ARCHITECT'S SUPPLEMENTAL INSTRUCTION NO. 7

DATE: April 08, 2024 PROJECT NO: 230117

RE: Streets of West Pryor – Lot 5 Core & Shell

DESIGN NO. UL U301

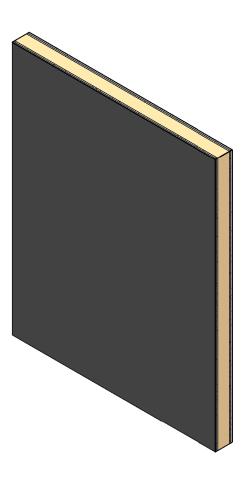
Sheet S-102 - Structural Wood Shearwall Schedule indicates the minimum structural Construction, while, the as-built structure has been erected with more than the minimum structural requirements using 2 layers of 5/8" Gyp on both sides to meet the UL rating of U301. The addition of the second 2 hr wall dividing Suites A & B will be built to match UL U301.

Supplementary data attached is UL U301 pdf document with assembly requirements of 2x6 wood stud.

FIRST FLOOR PLAN

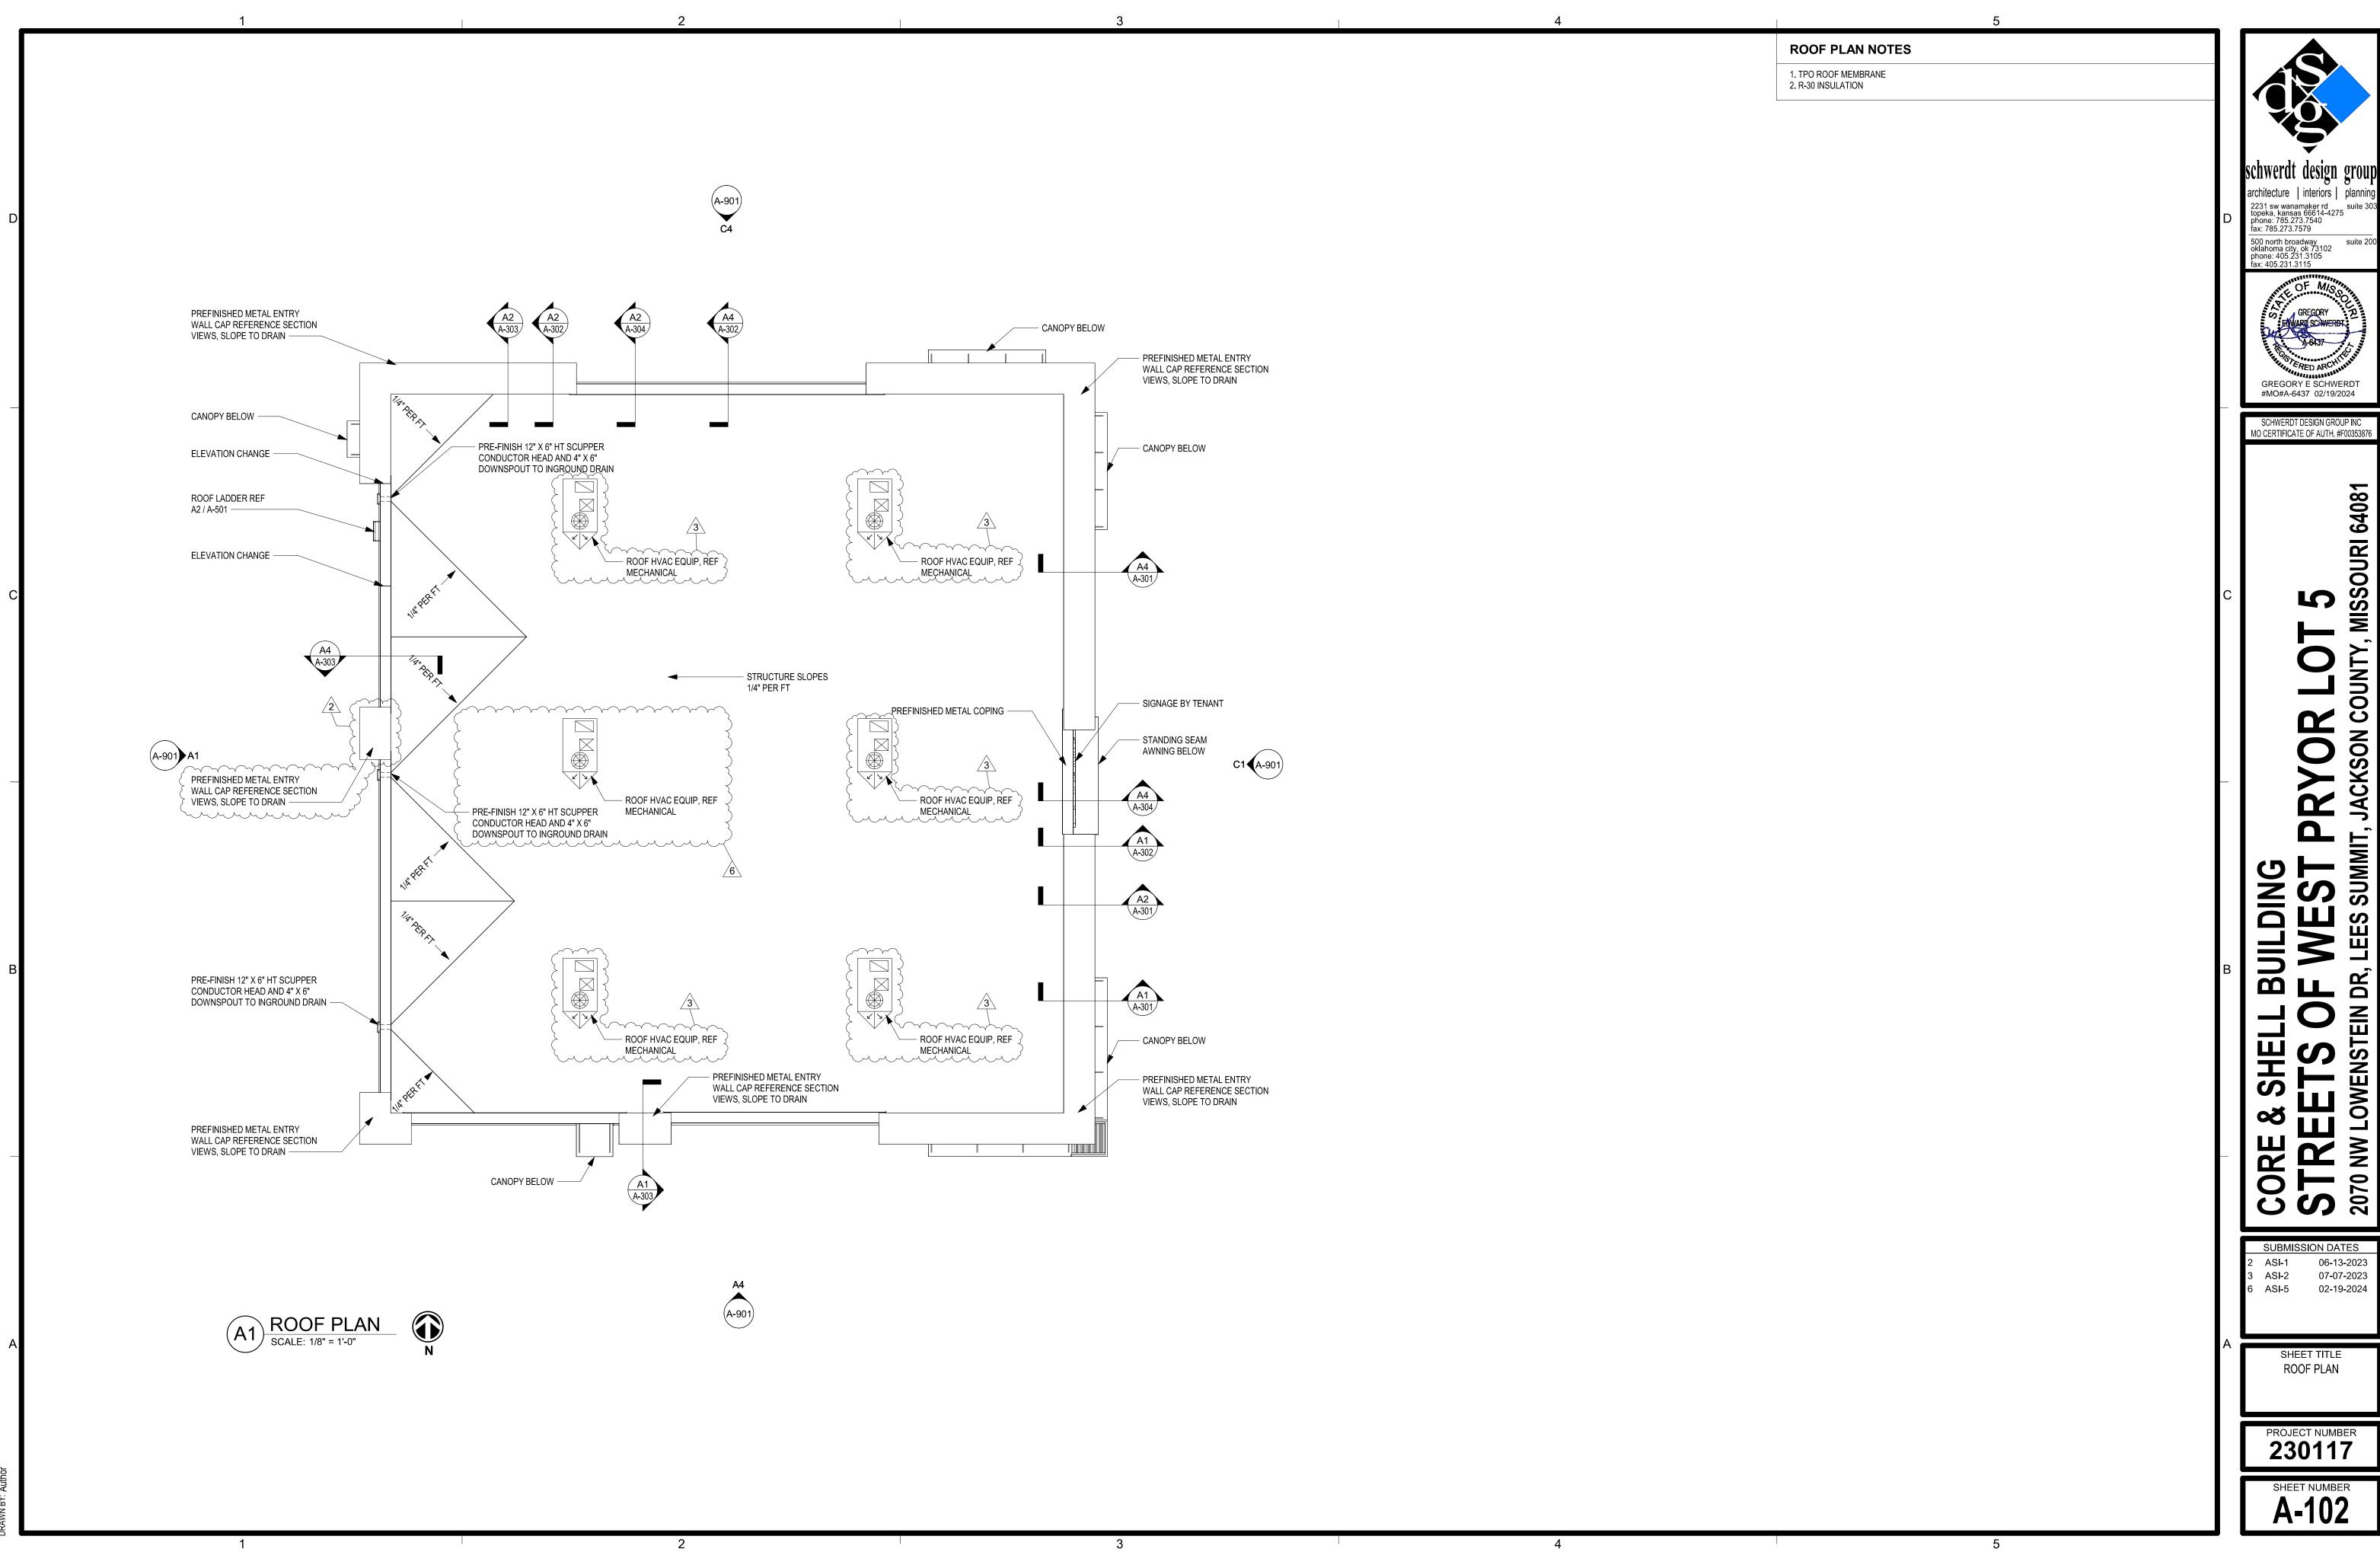
- A-1 Sheet G-001 Code plan updated to show 2 hr rated separation wall.
- A-2 Sheet A-101 Partition type 'P1' 2hr rated partition updated to call out and match structural 2x6 stud framing.

ROOF PLAN

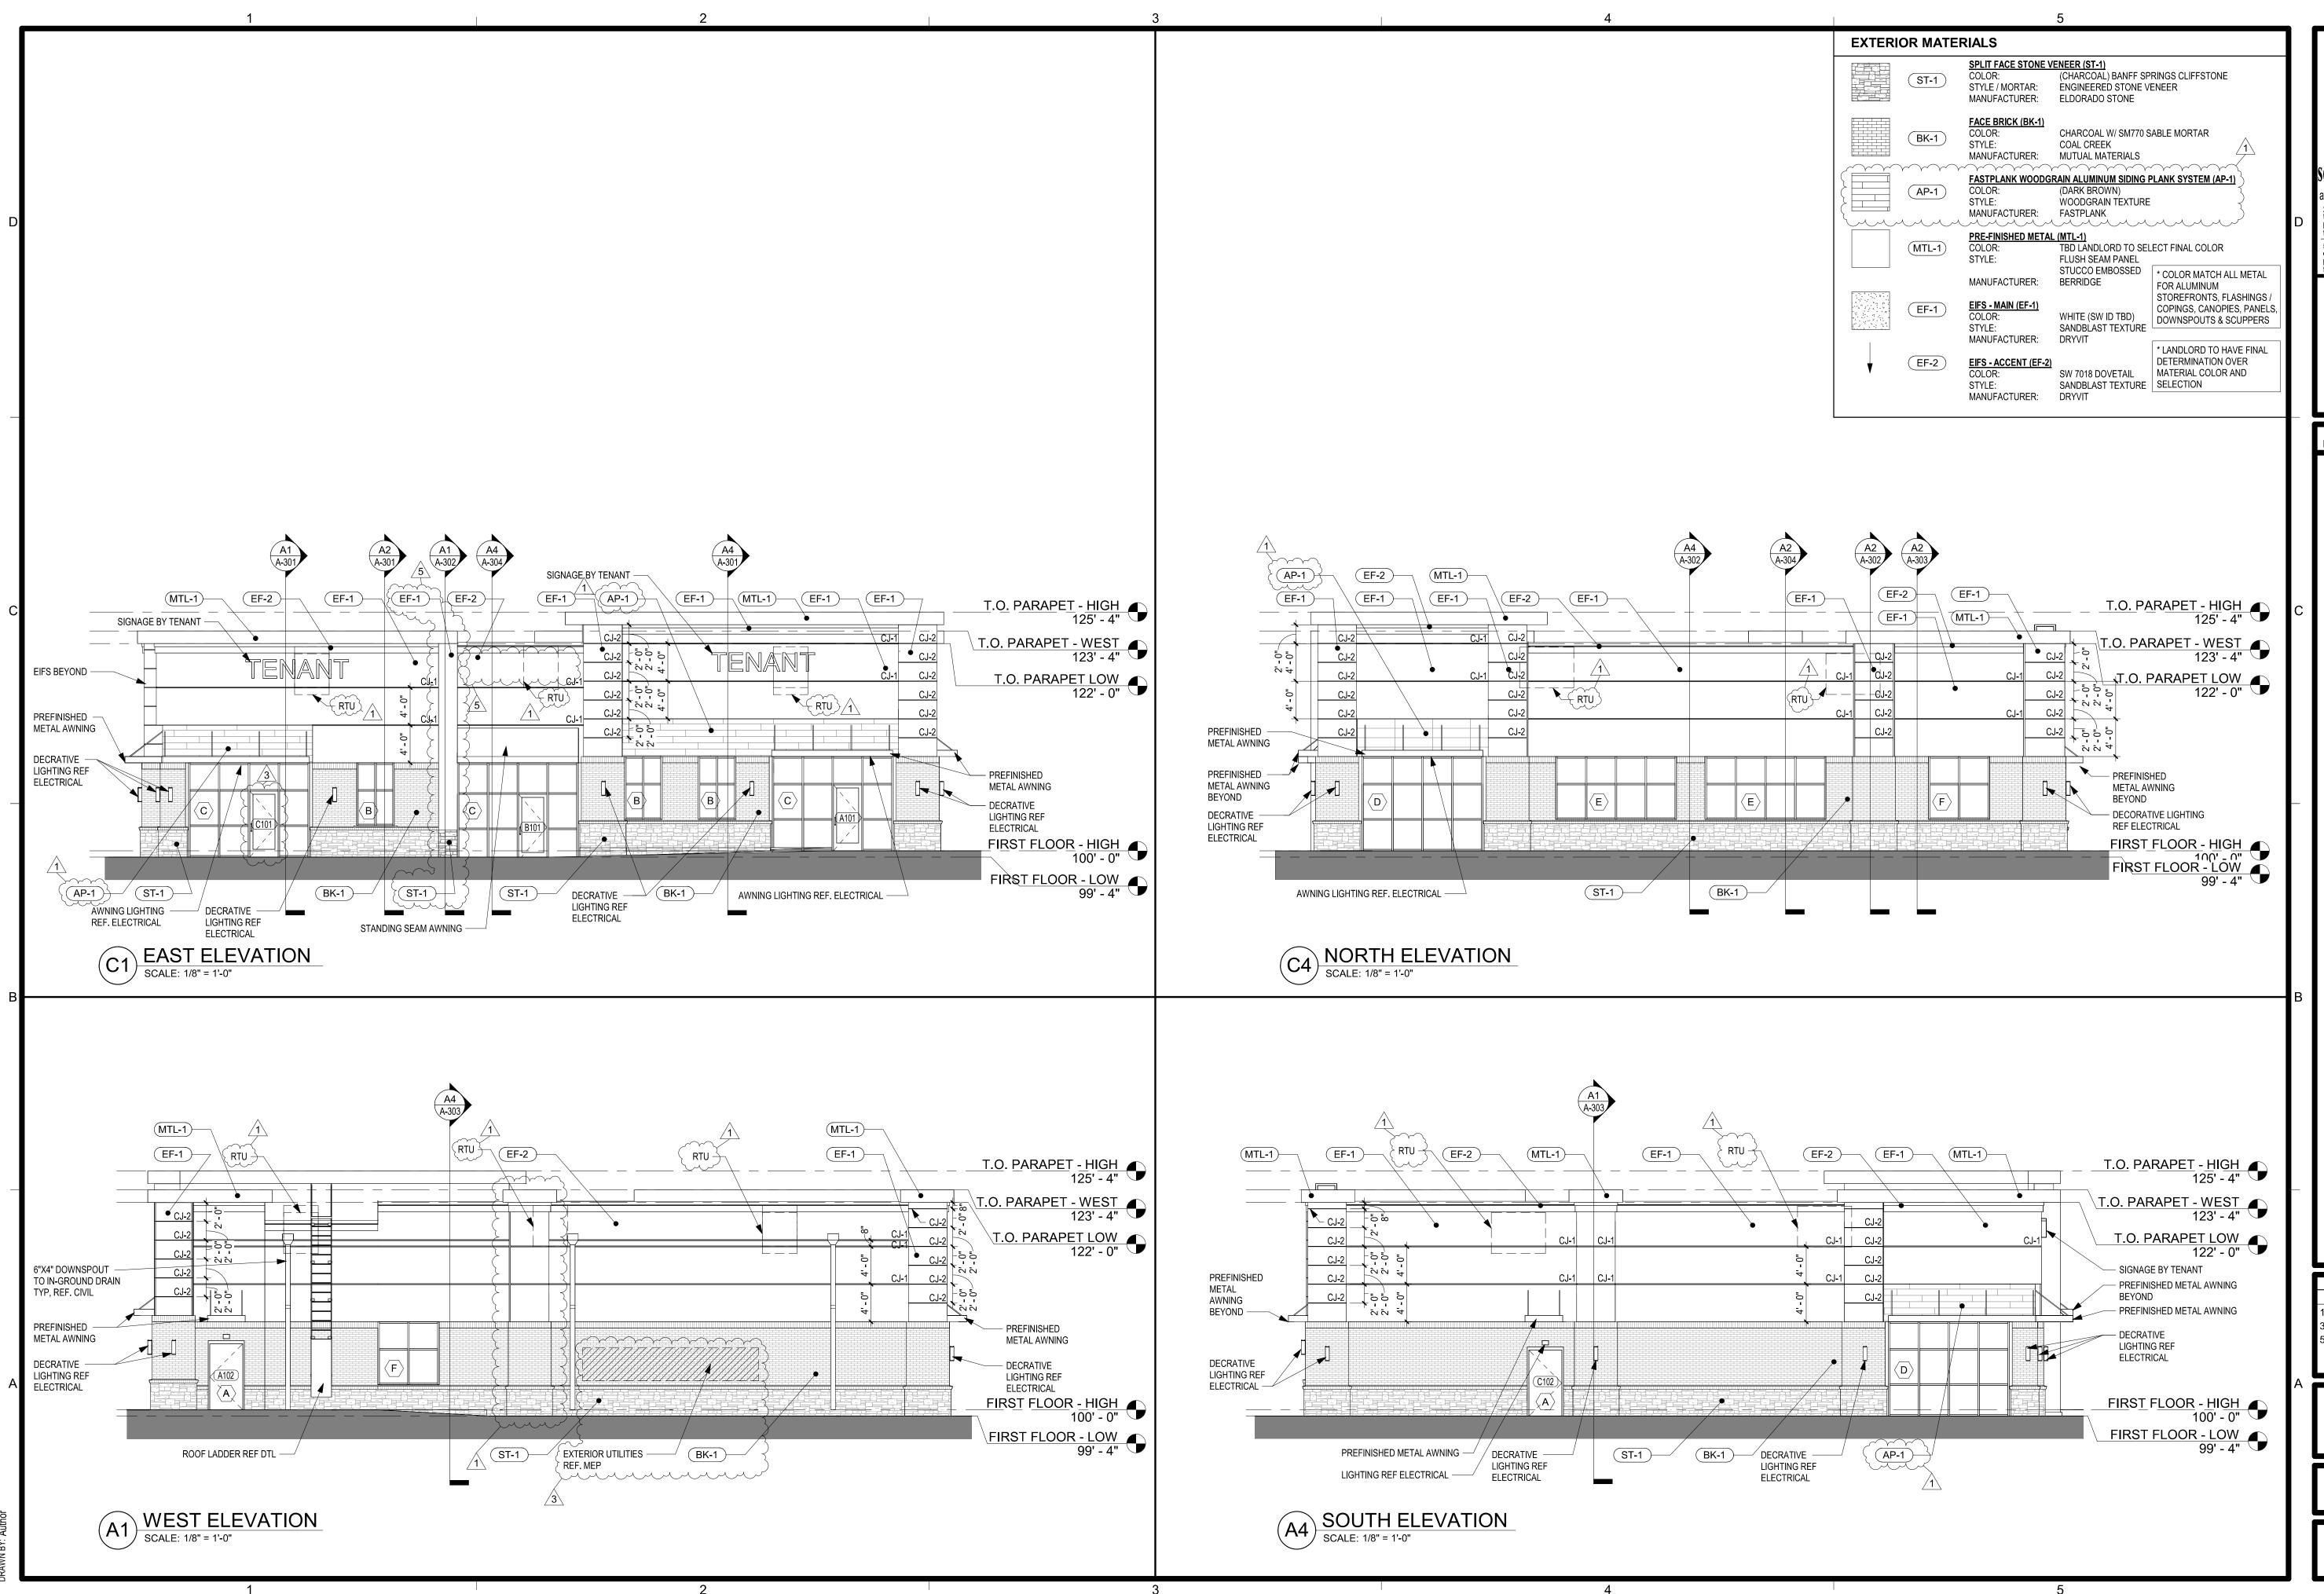
- A-1 Sheet G-001 Code summary updated with usable square foot occupant load calculations and exit requirements for tenant suites A, B & C.
 - A-1.1 Sheet G-001 Code plan updated with occupant load calculations and egress width for tenant suites A, B & C.
- A-2 Sheet A-101 Two hour rated demising wall added to full East to West length of the building spaced 21 feet from face of gypsum board to the other second two hour rated demising wall. Creating and dividing the Core & Shell building into now three separate tenant suites.
 - A-1.A Updating tenant suite designations as Suite A, B & C respectively.
 - A-1.B Updating tenant suite square footage.
- A-3 Sheet A-102 Roof Top Unit added to service enlarged Tenant Suite B space.

WALL FRAMING PLAN

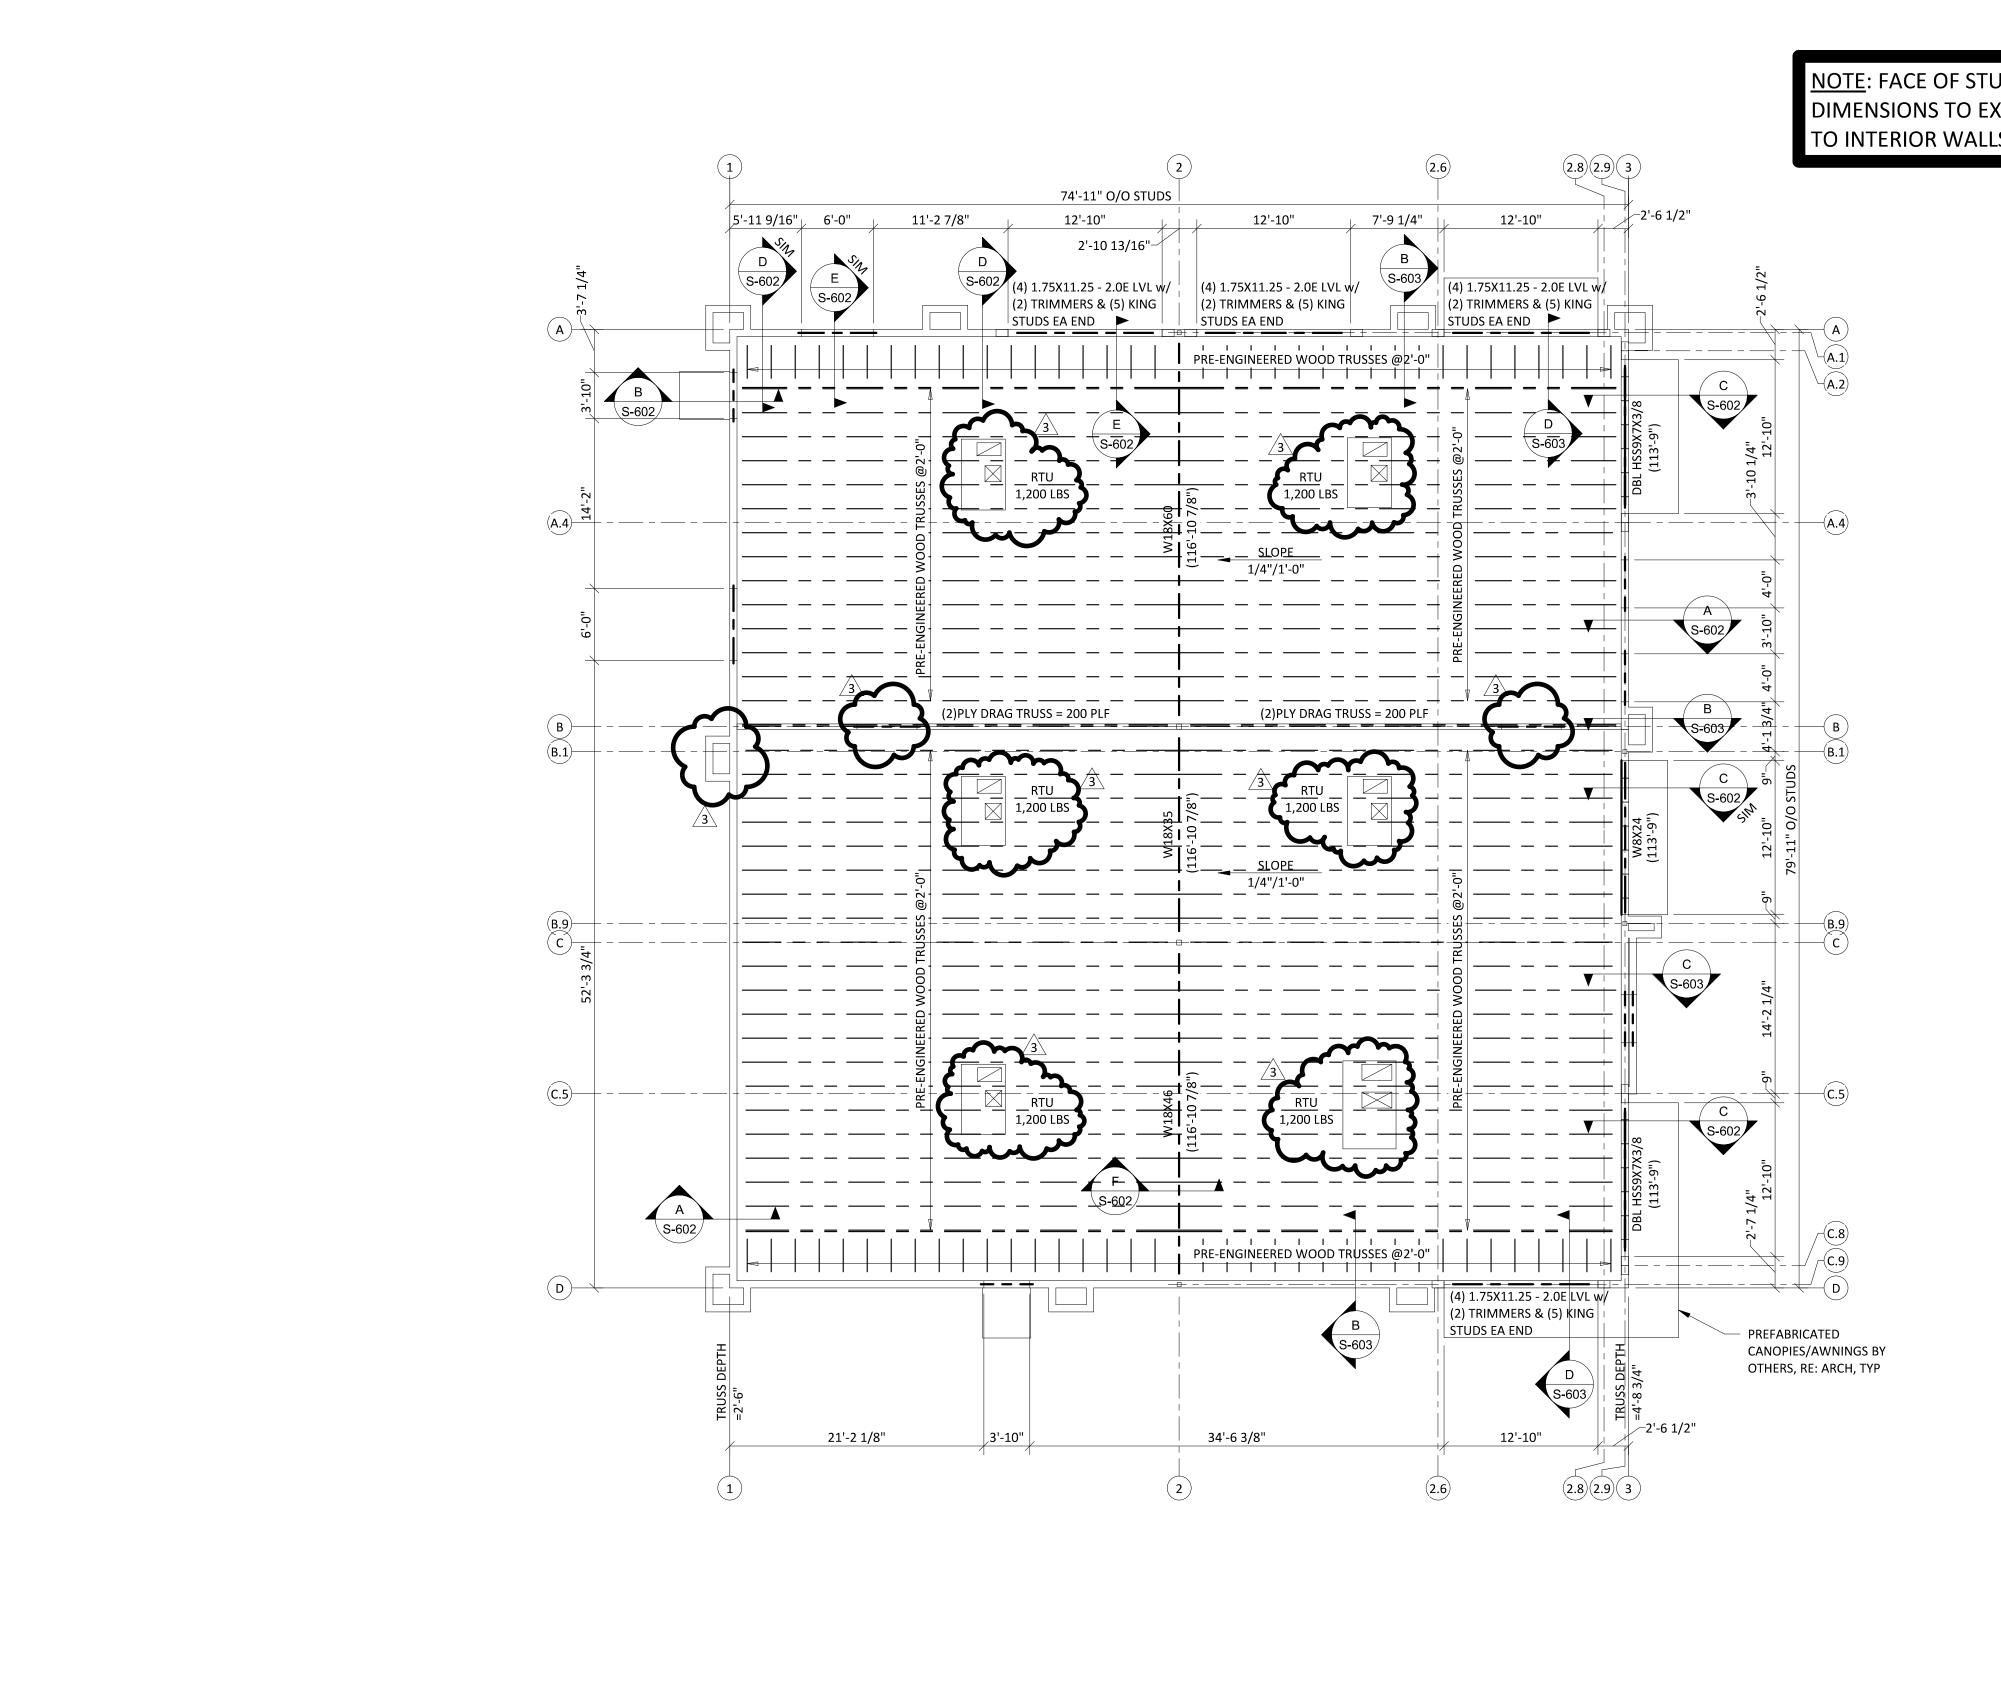
S-1 Sheet S-102 - Updated location of future pass-through openings on Suite C's South demising wall.
